subject MPWSP – Carmel Valley Pump Station Project Weekly Report (12/14/2020 – 12/18/2020)

MPR No. 2 Approval

RE: Minor Project Refinement Request No. 2 for the Monterey Peninsula Water Supply Project – (A.12-04-019) – Carmel Valley Pump Station

EL03

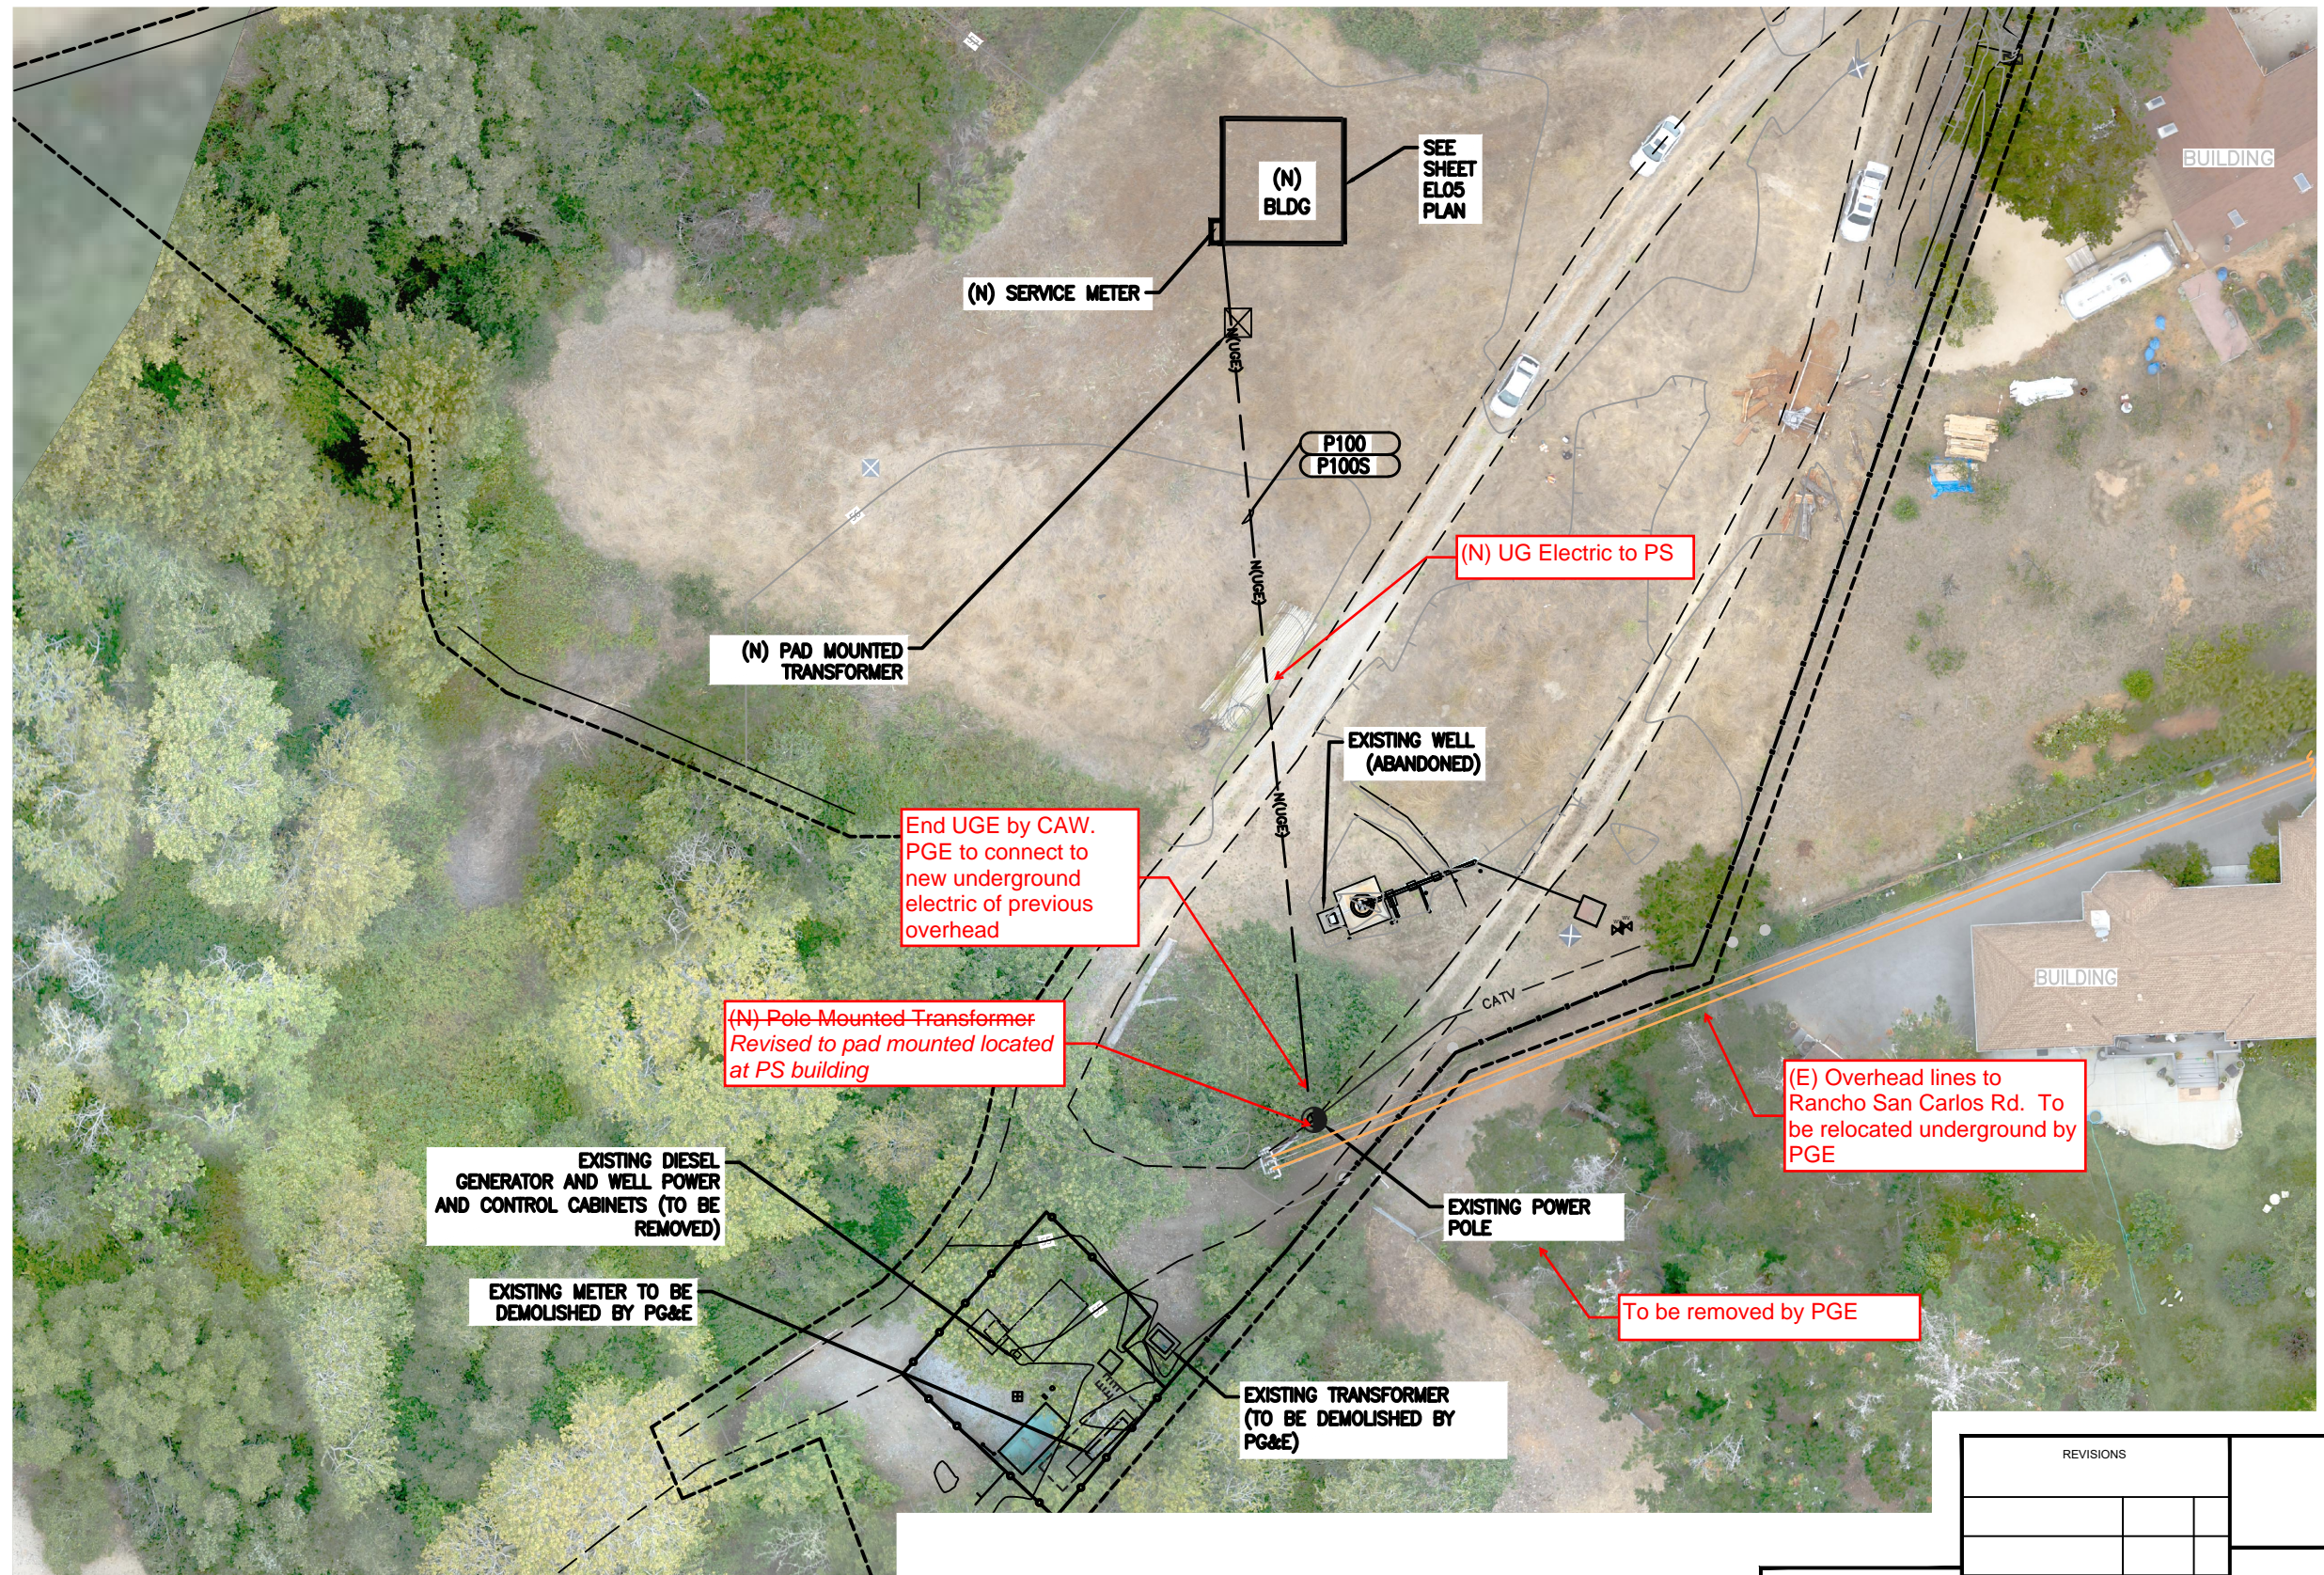
CalAm submitted Minor Project Refinement Request (MPR) No. 2 to the CPUC on December 14, 2020. The original project design included installation of underground power lines to connect the Pump Station to an existing Pacific Gas and Electric (PG&E) power pole on the project site. Independent of the project, PG&E plans to underground its existing overhead power lines from the power pole to Rancho San Carlos Road and remove the existing power pole. This independent PG&E project requires that CalAm construct a new 76" x 70" pad-mounted transformer within a small section of the approved gravel yard near the Pump Station that would replace the existing pole-mounted transformer (see attached figures).

(N) Pole Mounted Transformer Revised to pad mounted located at PS building

CalAm is authorized to proceed with MPR No. 2 upon condition that all proposed actions and construction is carried out in accordance with the methods and conditions described in NTP-3.
